CMS Internal Note

16 March 2006

Modification of the CMS Regional Calorimeter Trigger Electron Identification Card for RCT Crate Slot 6 to Control Regional Boundary Data Sharing for Towers of Identical Energy

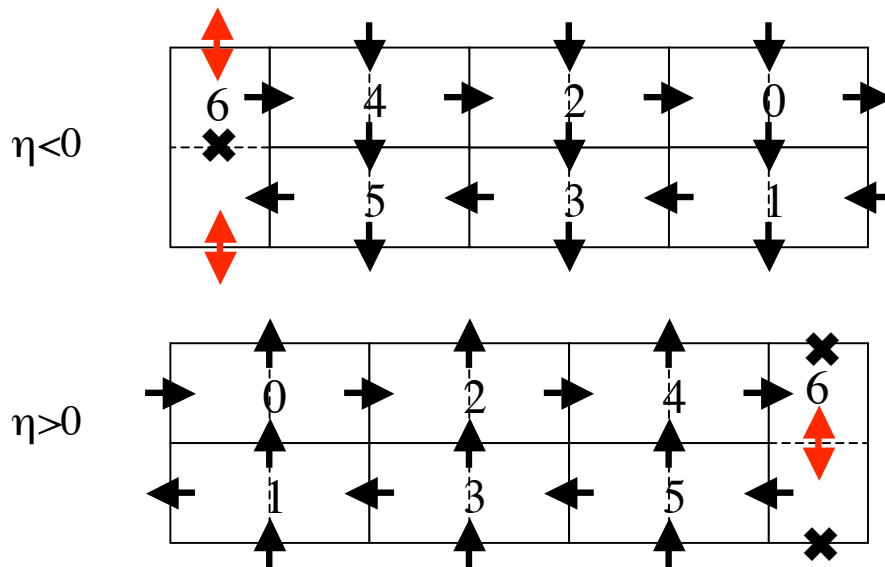
Figure 3 shows the configuration of cards and regions for two crates, the upper for $\eta < 0$ and the lower for $\eta > 0$. Each arrow represents which region or card a pair of towers with identical energy would be assigned to, with $TP_LF=1$ for cards 0,2,4,6 and $TP_LF=0$ for Cards 1,3,5 ($\eta < 0$) and $TP_LF=0$ for Cards 0,2,4,6 and $TP_LF=1$ for Cards 1,3,5 ($\eta > 0$). However card 6 has a problem. Setting $TP_LF=1$ for $\eta < 0$ causes duplication of candidates at the cable sharing boundary (the double arrow), and anything at the center boundary disappears (the “x”). Setting $TP_LF=0$ as shown for $\eta > 0$ causes candidates on the internal region boundary to be duplicated (one in each region) and will make the cable sharing ones disappear! Changing the value for either card 6 to its opposite affects the 4/6 and 5/6 boundaries, either causing duplication, or disappearance.

Figure 3: If the cards are left as built and only one value of TP_LF is set for each card. The single arrows show to which region a candidate would be assigned if the two towers have equal energy. For EIC 6, this becomes a problem, as candidates are duplicated in two regions (double arrows) or lost outright (crosses).

Figure 4: After reconfiguring EIC 6, no candidates are lost. Duplicate candidates are possible on the Card 6 Region 0 – Card 4 Region 1 boundary for $\eta < 0$ and the Card 6 Region 1 – Card 5 Region 1 boundary for $\eta > 0$. This is only when the tower energies are identical.

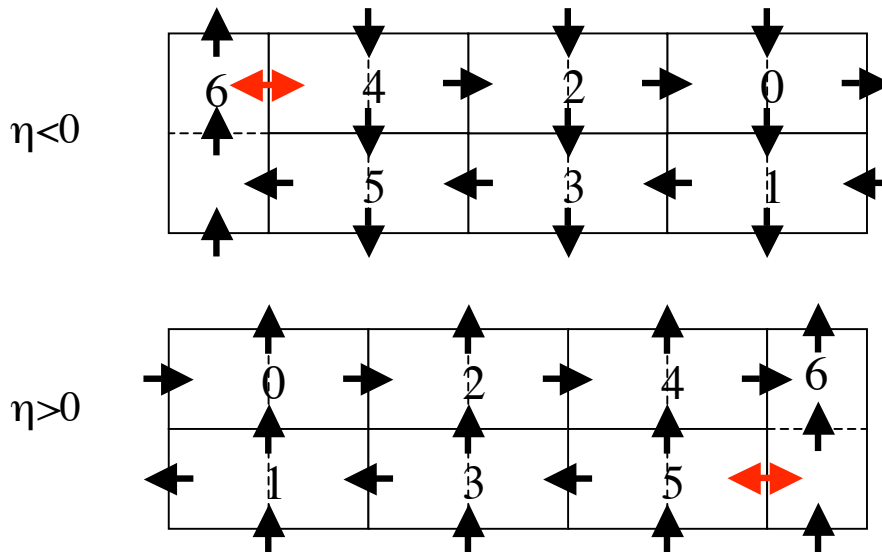
A new TP_LF bit was created – one that only accessed the EISO for Region 1. The original bit now only accesses the EISO for Region 0. This is only implemented on certain cards to be used in EIC slot 6 of the RCT crate. Address \$00 bit 0x40 is either 0 or 1 depending on the choice of TP_LF for Region 1. Configuring the EIC’s as in Table 1 causes no candidates to be lost, and a duplication of candidates along the RC/EIC 6 Region 0 and RC/EIC 4 Region 1 ($\eta < 0$) and RC/EIC 6 Region 1 and RC/EIC 5 Region 1 ($\eta > 0$) boundaries. No perfect solution could be found, so this was preferred to losing candidates.
